LASS-II Rapid Geodetic Survey System (RGSS)

FINAL TECHNICAL REPORT

LASS-II RAPID GEODETIC SURVEY SYSTEM (RGSS)

CONTRACT NO. DACA 72-84-C-0003

Figure 4. CDU Modifications

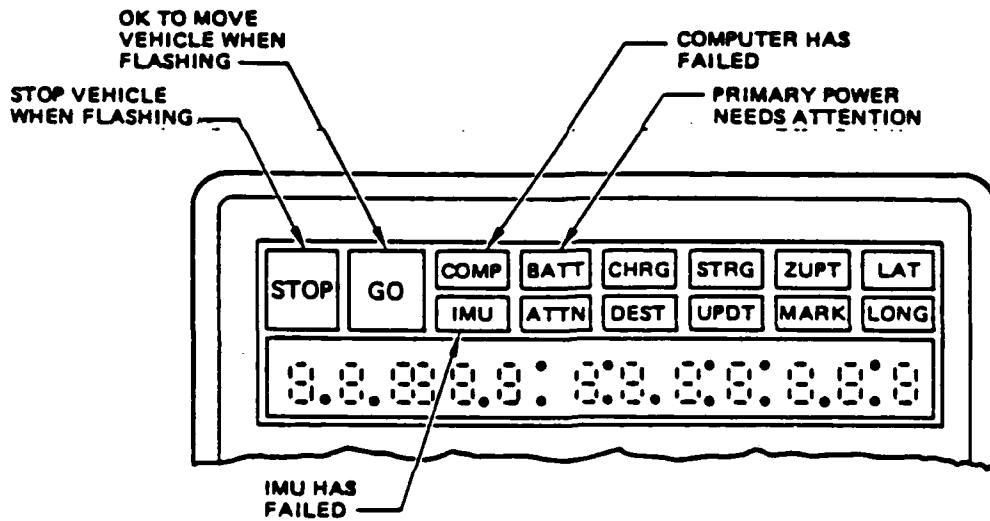
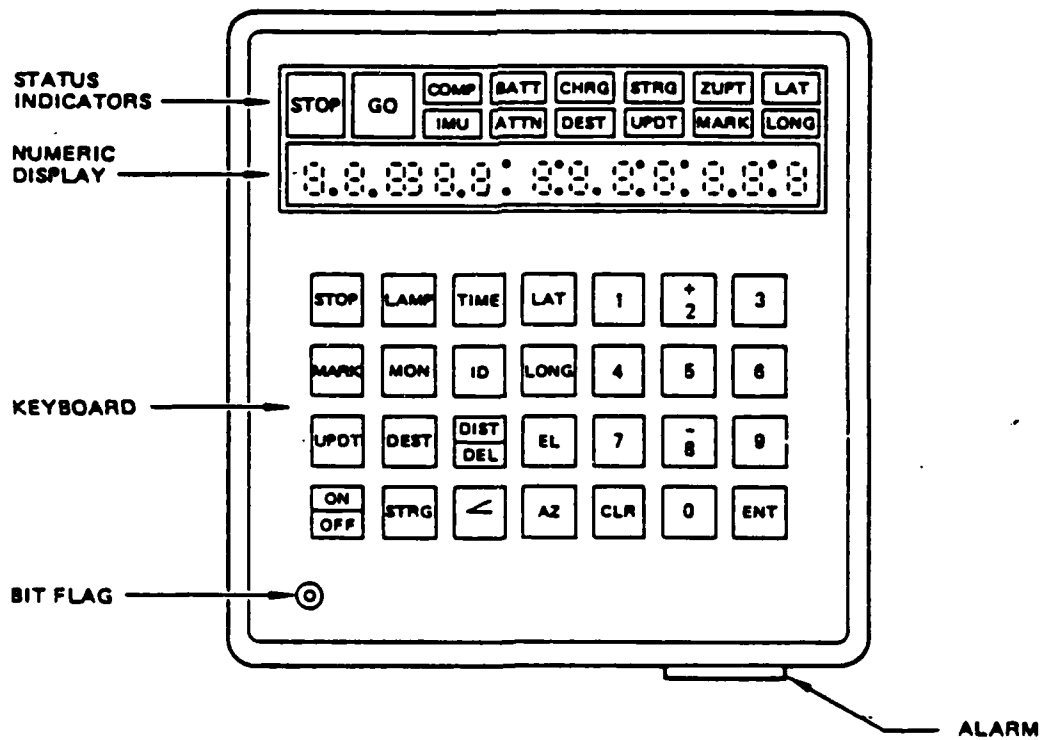
2.9.2 CDU Modifications. For CDU modifications, see figure 4.

SUBJECT: RGSS STABLE ELEMENT WIRING MODIFICATION

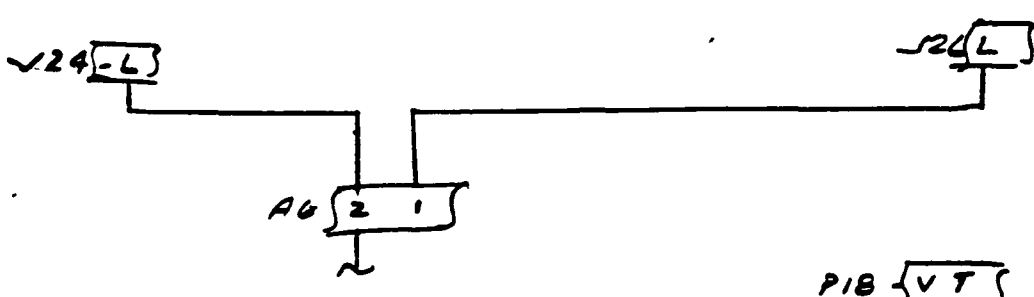
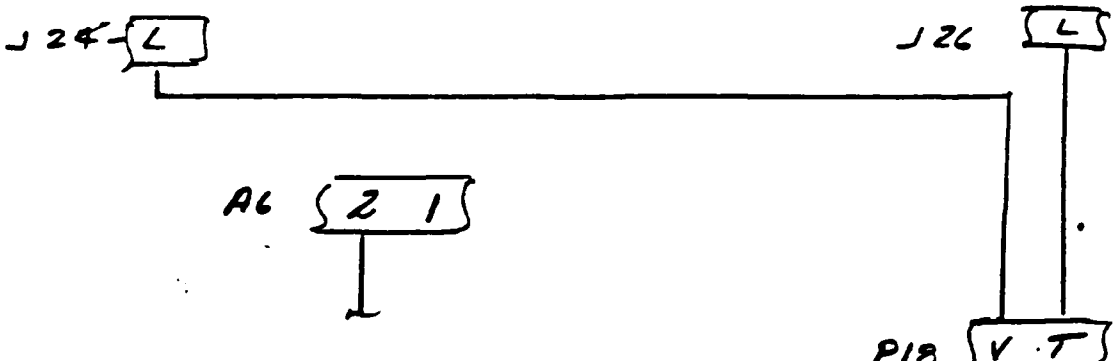
Add the following information to DFM 16.2/2

Remove wires from J24-L to A6-2
J26-L to A6-2

Add wires from J24-L to J18-V
J26-L to J18-T

Reason: Isolation of accelerometer scale factor returns
to quantizer. Reference ECN (Electrical Change
Notice) 143849 and 143850 (attached).

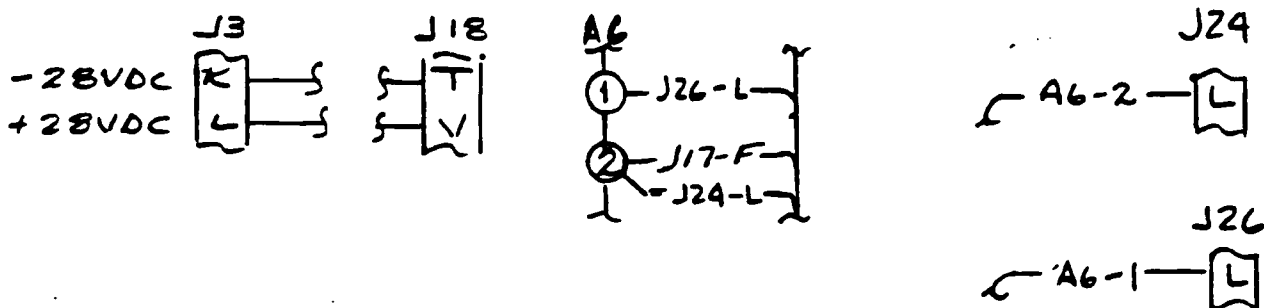
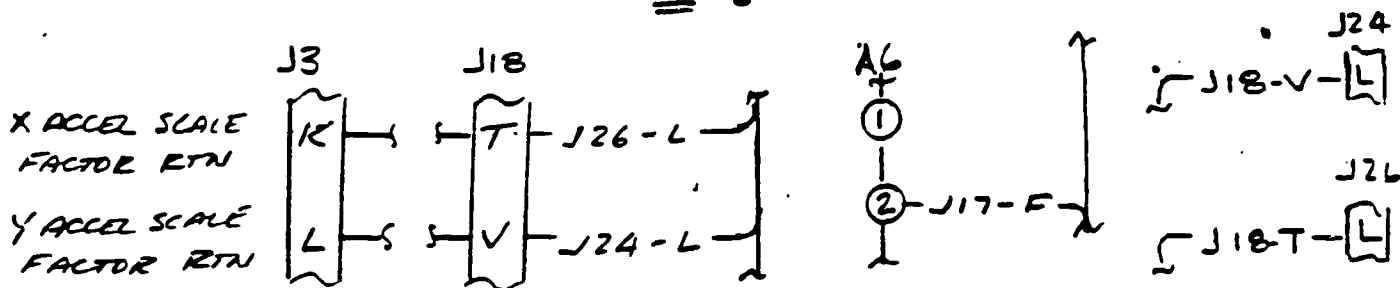
SCHEMATIC 867940 CHANGE FROM:**TO :**

SCHEMATIC B67940 - CHANGE TO:

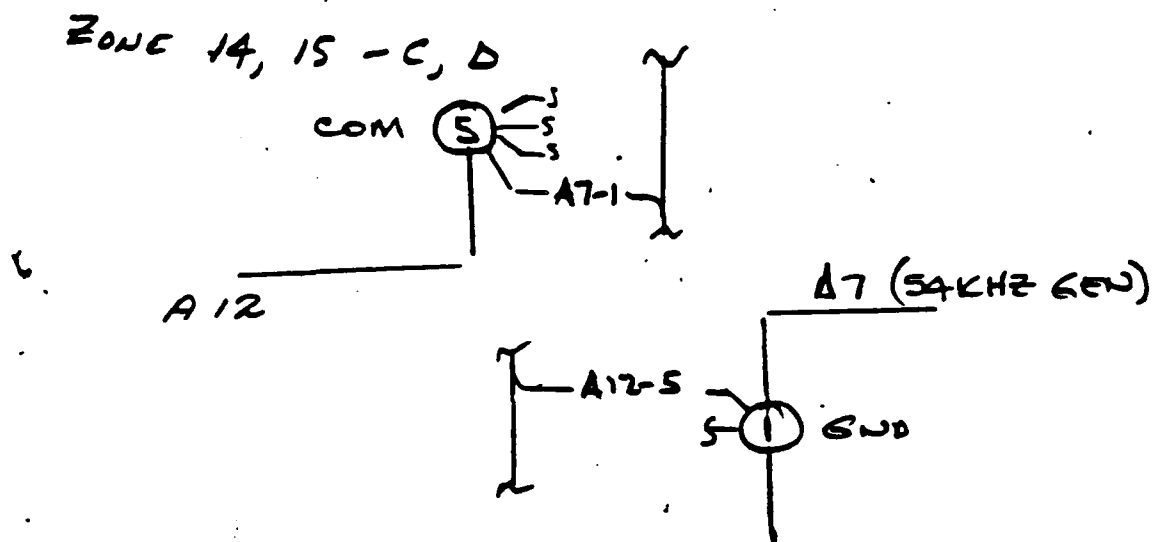
ZONE 14, 15 - C, D

PROJECT <i>RGSS</i>	UNIT <i>IMU</i>	MODULE <i>ACCEL</i>	ASSEMBLY TO BE CHANGED <i>B64412</i>	SHEET 1 OF 2
------------------------	--------------------	------------------------	---	-----------------

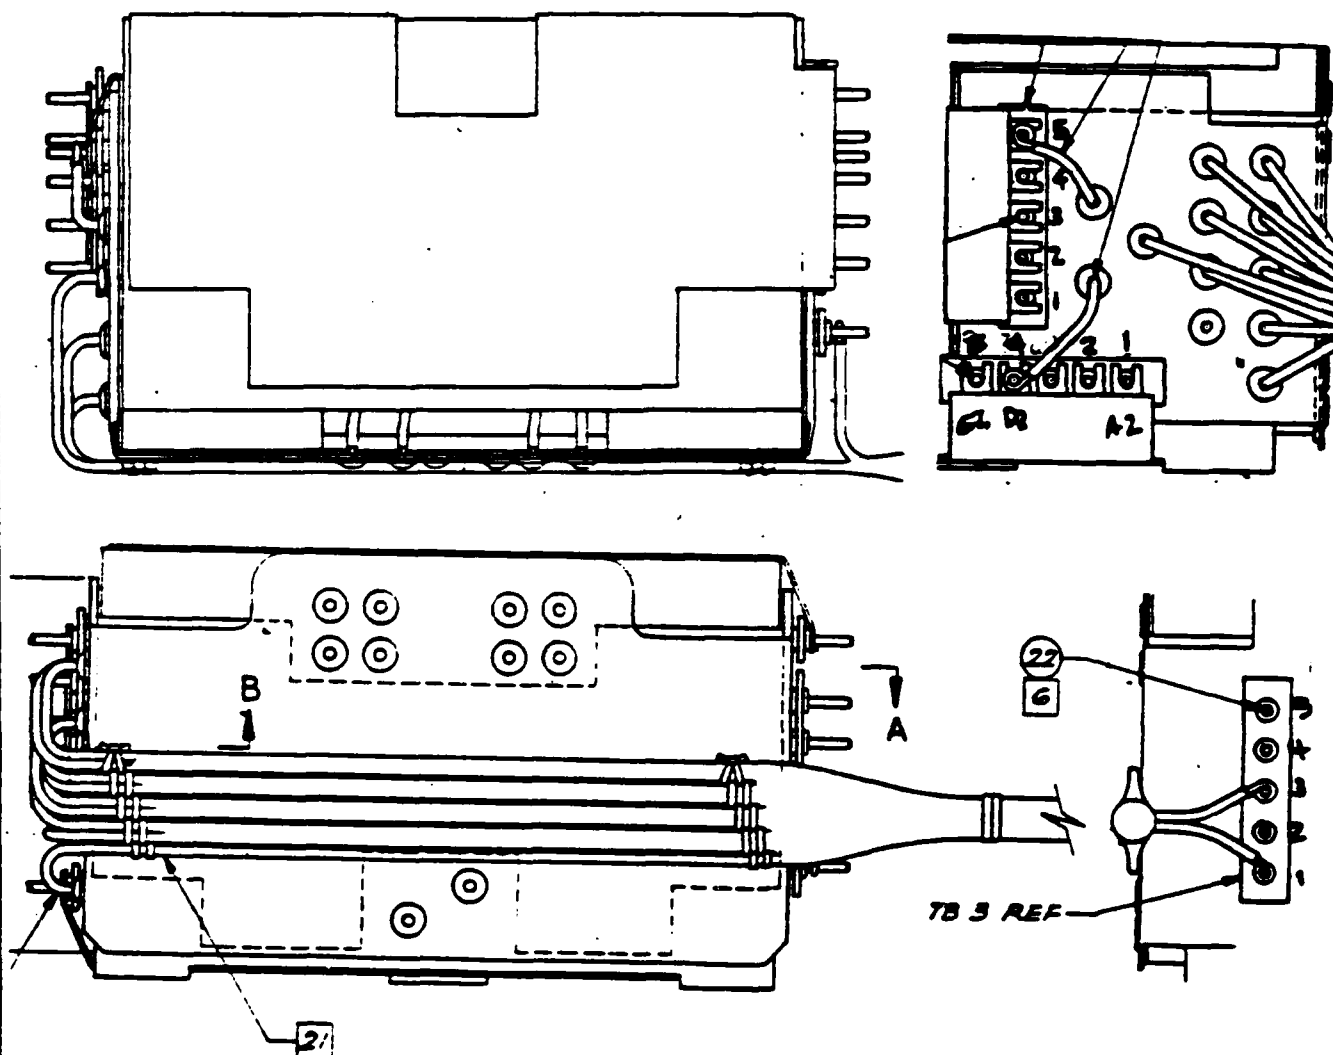
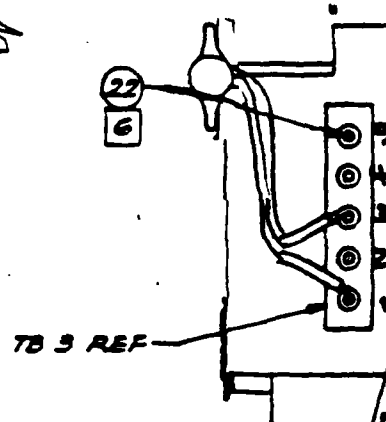
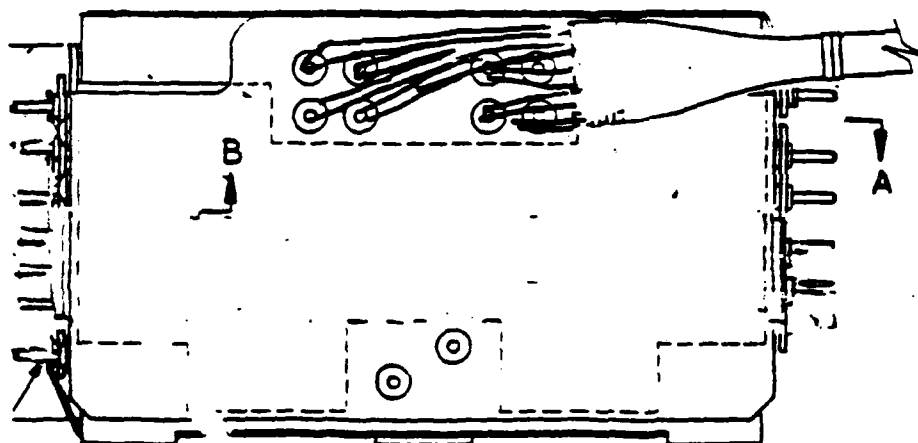
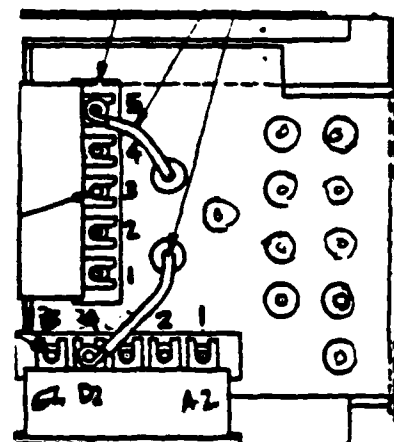
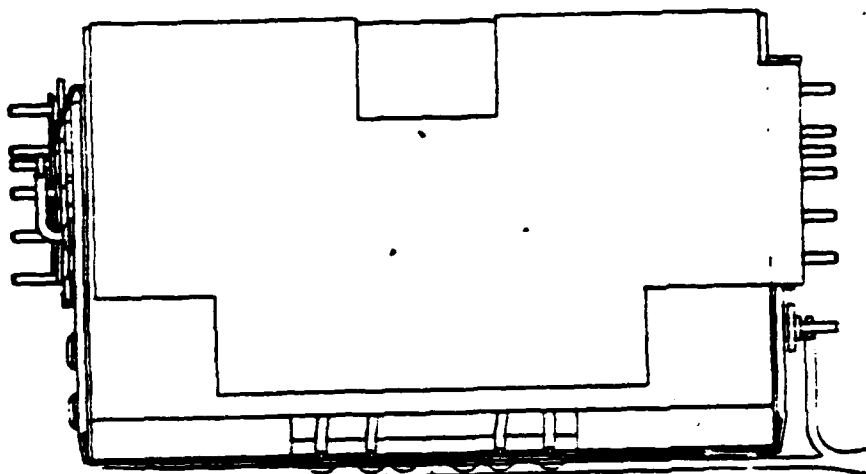
Assy B64412 CHANGE FROM:

DELETE NOTE [2] AND REFERENCE TO SAME

SUBJECT: QUANTIZER MODIFICATIONS FOR CHANGE OF
LEVEL AXES ACCELEROMETERS

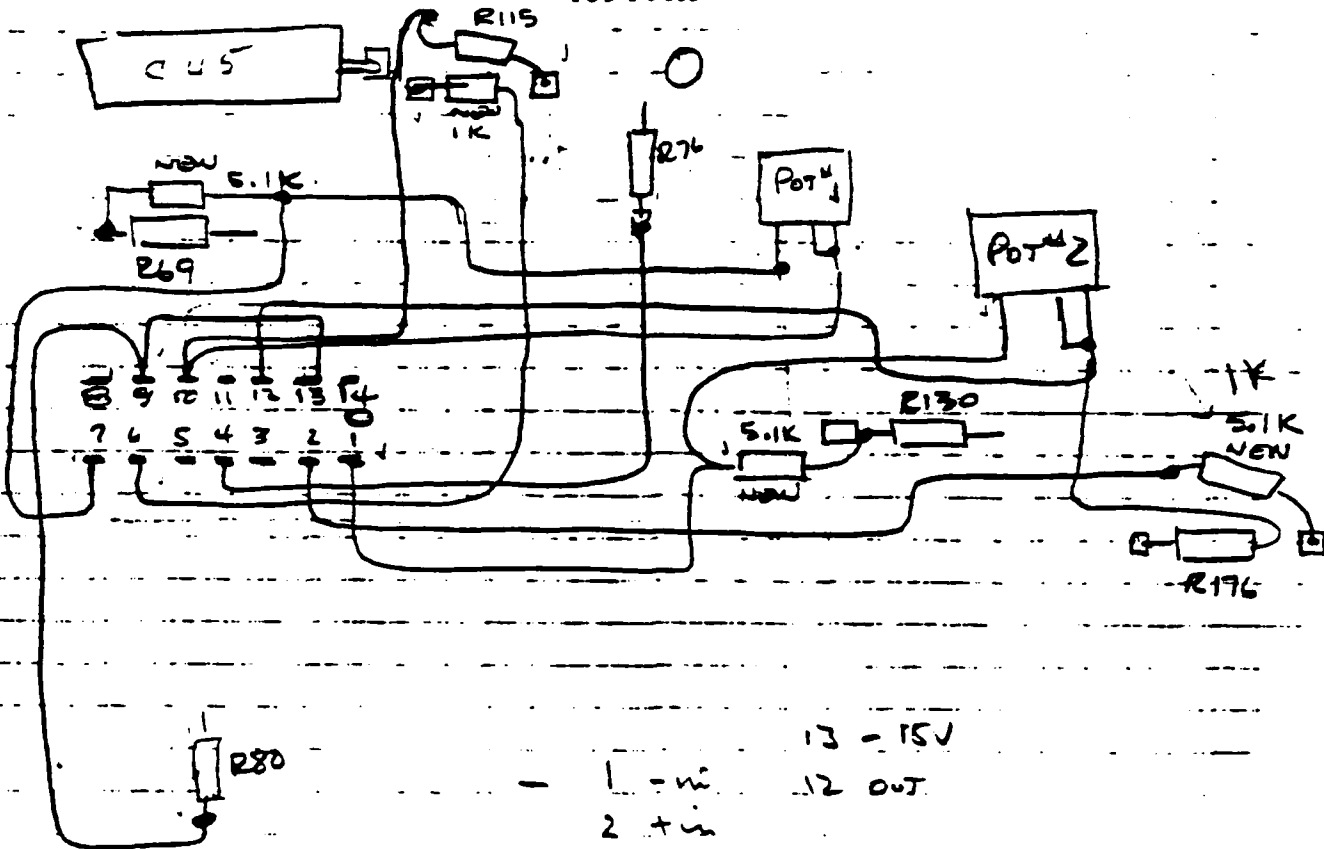
Changes to Quantizer assembly 880945 shall be made under "Demo Systems" ground rules, which include red lined drawings. The assembly shall be modified to accept the A1000 inputs for the level axes accelerometers in place of the present A200D accelerometers. The original Quantizer scaling accuracy, tracking and tolerances are to remain unchanged. The modifications are included in the red lined drawings attached. The drawings and areas of change are defined.

Remove C34, C35, C36
C60, C61, C62

Remove R112, R103, R164, R173

Remove R287, R284, R291, R295

Remove R111, R102, R163, R172

Remove R58, R119

Remove R289, R282, R290, R297

* Remove R288, R283, R291, R296

REPLACE WITH

PROJECT R655	UNIT IMU	MODULE QUANTIZER	ASSEMBLY TO BE CHANGED	SHEET 1 OF 2
------------------------	--------------------	----------------------------	------------------------	-----------------

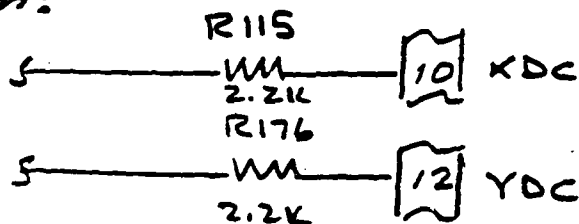
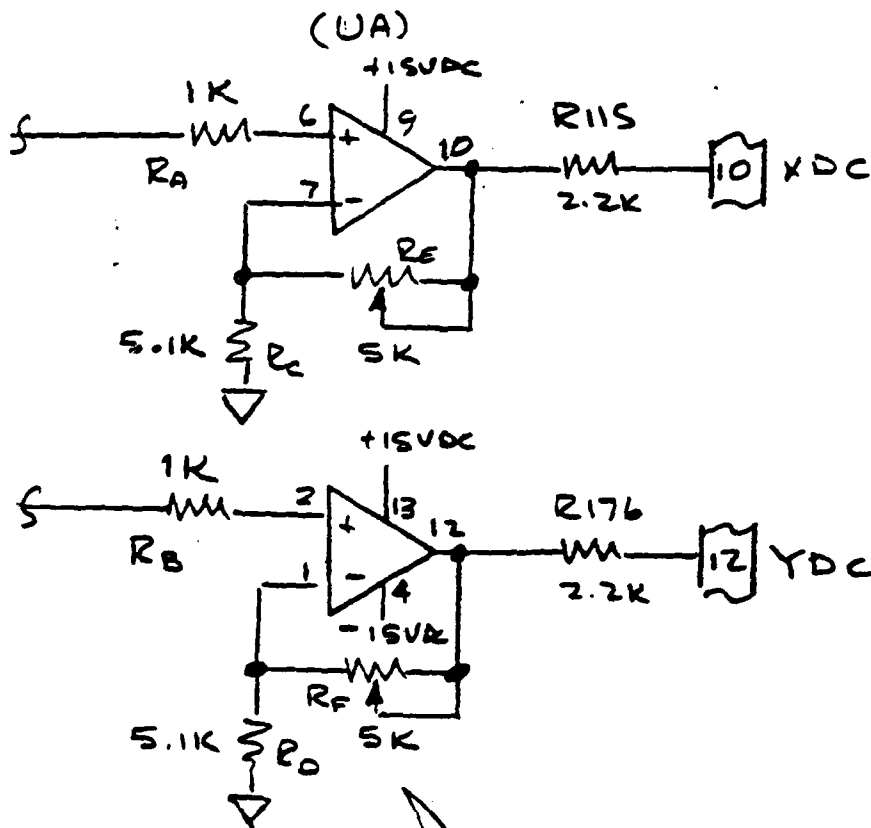
SCHEMATIC**CHANGE FROM:****TO:**

CHANGE ITEM 104 TO QTY 7 - ADD RA, RB
(944917-1001)

SCHEMATIC 880945

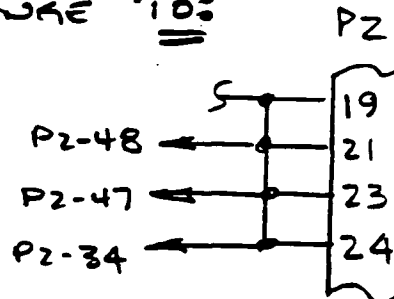
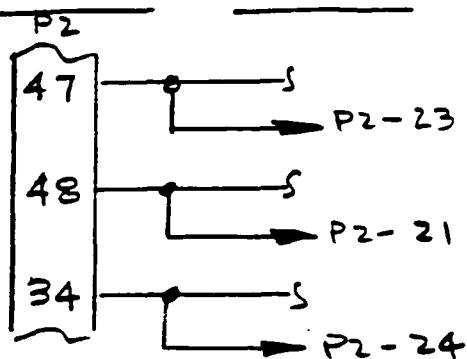
CHANGE TO:

A-11 880945

ADD JUMPER
